BEFORE THE ATOMIC SAFETY AND LICENSING BOARD

In the Matter of )  
METROPOLITAN EDISON COMPANY ) Docket No. 50-289  
(Three Mile Island, Unit 1) )

NRC STAFF RESPONSE TO UNION OF CONCERNED SCIENTISTS  
SECOND SET OF INTERROGATORIES

FIGURE 4.4-1  
(FROM REF. 3)

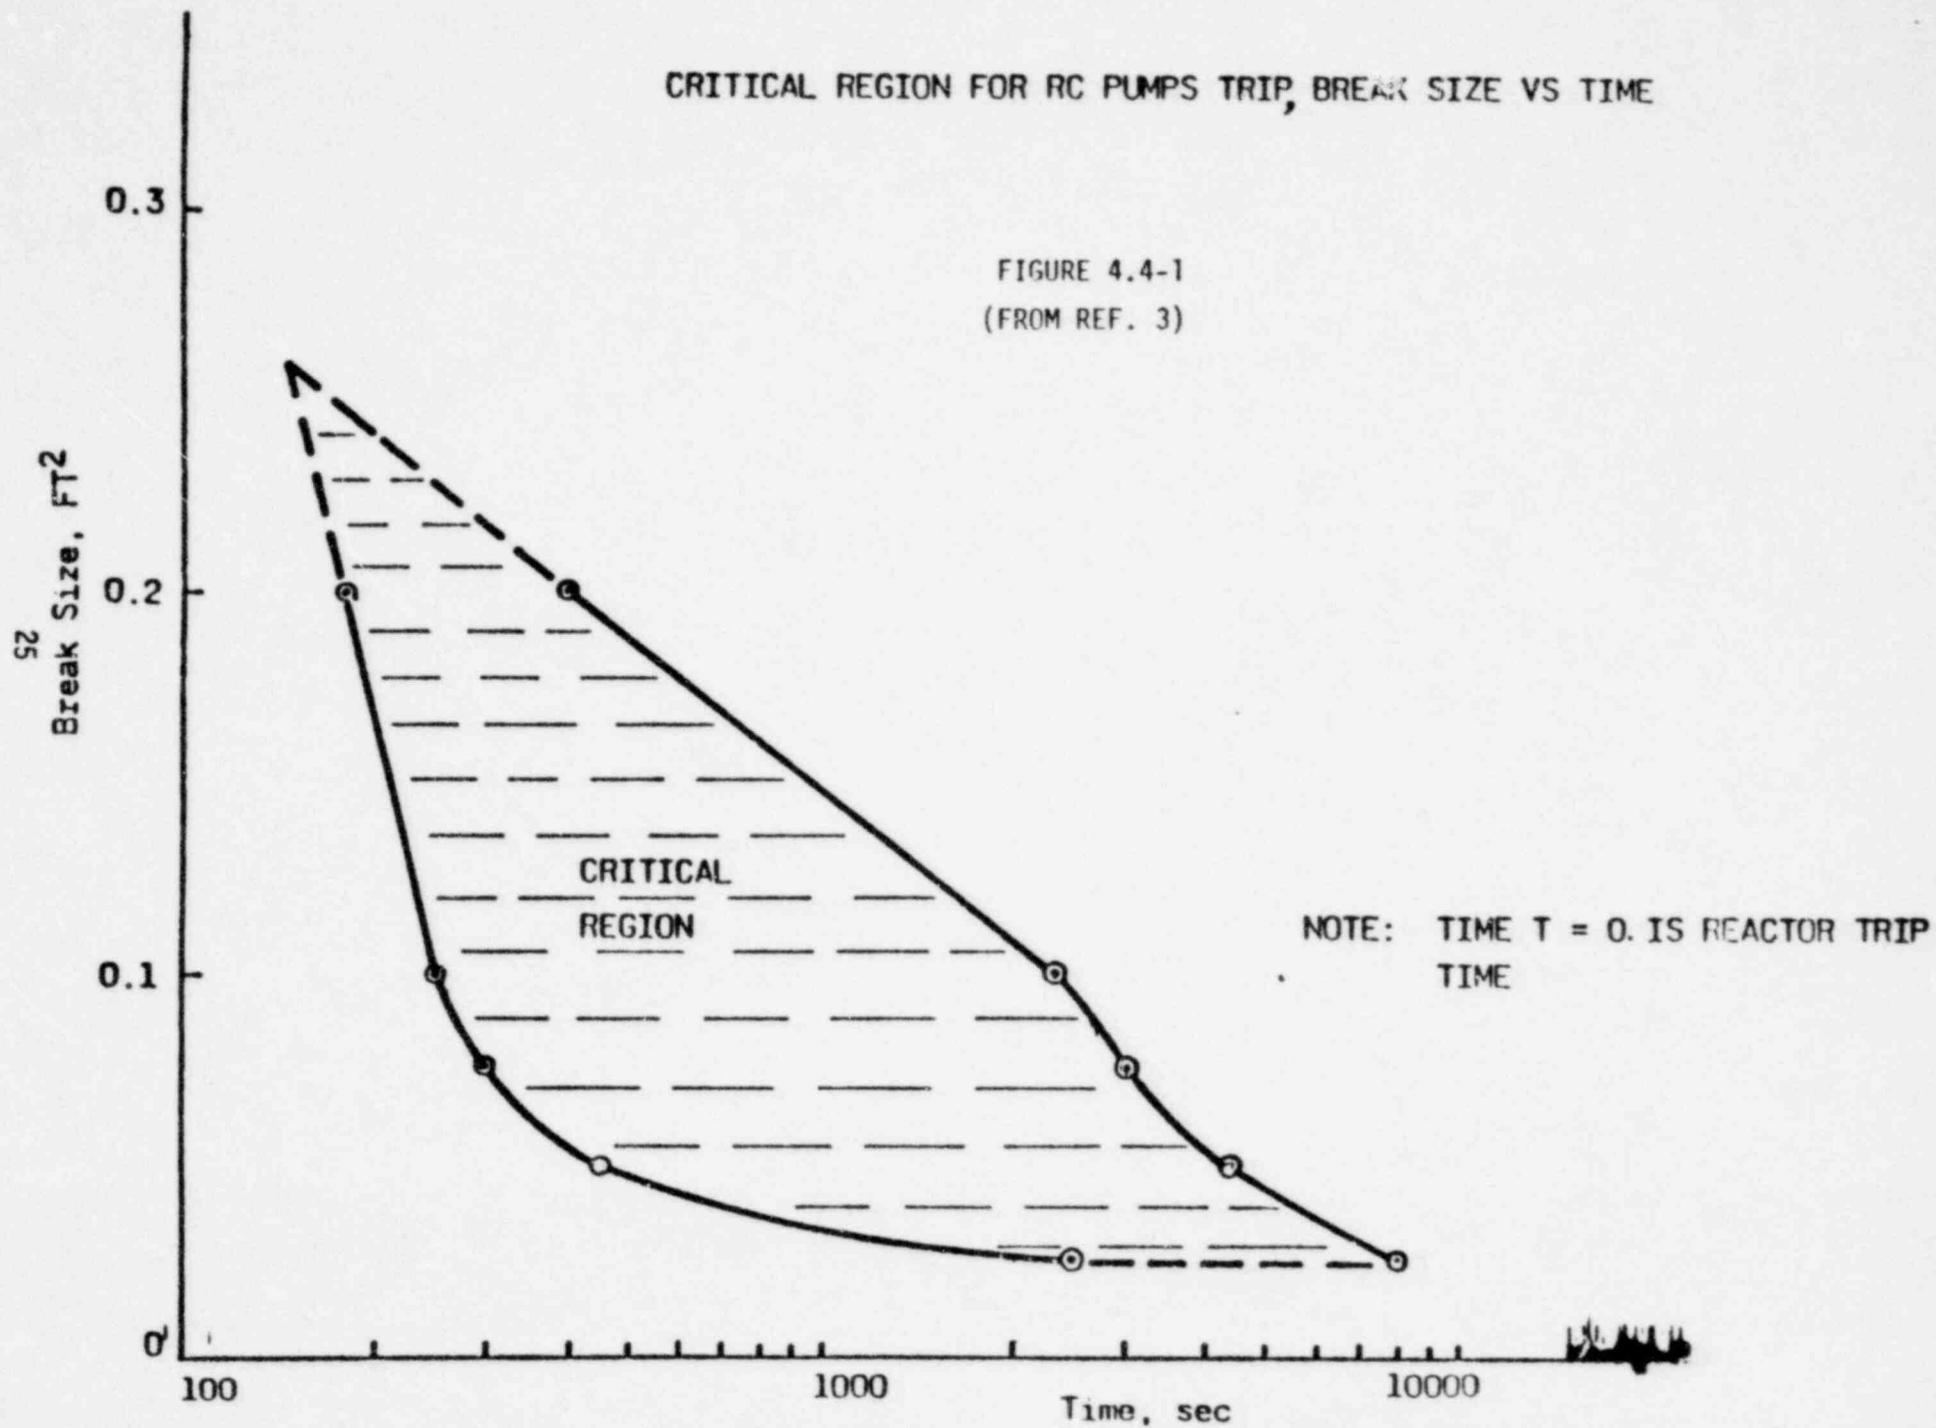
NUREG-0623 states that "small break LOCA's with the pumps operational or with delayed trip can result in more severe consequences than when the pumps are tripped early in the accident." (p. 1) In contrast, the staff states on page C2-18 of the Status Report that "the proposed logic [the automatic pump trip] is intended to preclude pump trip during ... very small breaks where maintenance of forced cooling is desirable." Please answer the following:

- a. Specify the spectrum of break sizes and locations where maintenance of forced cooling is desirable and those where pump trip is desirable.
- b. Discuss the means by which the operator will be able to determine whether the pump should be tripped or forced cooling should be maintained.

The spectrum of break sizes where tripping of the pumps early in the accident is necessary to prevent unacceptable consequences was calculated by Babcock and Wilcox to range from about  $0.25 \text{ ft}^2$  to  $0.025 \text{ ft}^2$ .

It should also be noted that for a given break size, a corresponding given period of time in the accident is also calculated to exist in which pump trip produces unacceptable consequences. This is shown in the accompanying figure.

The analyses performed by B&W, upon which the accompanying figure is based, assumed the break was located on the bottom of the cold leg pump discharge piping. Comparable analyses for a spectrum of break sizes assuming breaks at different locations on the circumference of the pipe (e.g., pump suction piping, hot leg piping) were not performed. One sample hot leg break analysis was performed and showed the results to be less severe than an identical analysis with the break in the cold leg.

It is concluded that for break locations other than the bottom of the cold leg discharge piping, the critical region shown on the accompanying figure would be smaller.

Until the recommendation requiring automatic pump trip is adapted by the Commission, the emergency procedures require the operator to manually trip all of the reactor coolant pumps upon reactor trip and actuation of the High Pressure Injection (HPI) System on low pressure. This criteria was chosen because HPI actuation on low pressure will occur for all breaks within the critical region and provide an easily recognizable signal for the operator. Moreover, the characteristics of small breaks are such that break sizes and locations which would permit continued pump operation cannot be distinguished by the operators from break sizes

and locations which do require pump trip. Finally, the critical region on the accompanying figure, within which early pump trip is required, is based only on analysis.

The staff has pointed out in NUREG-0623 that the analysis models used to produce these results are presently unverified and could have a large uncertainty associated with them.

Consequently the critical region shown on the accompanying figure also has an uncertainty associated with both critical break size as well as the critical pump trip time.
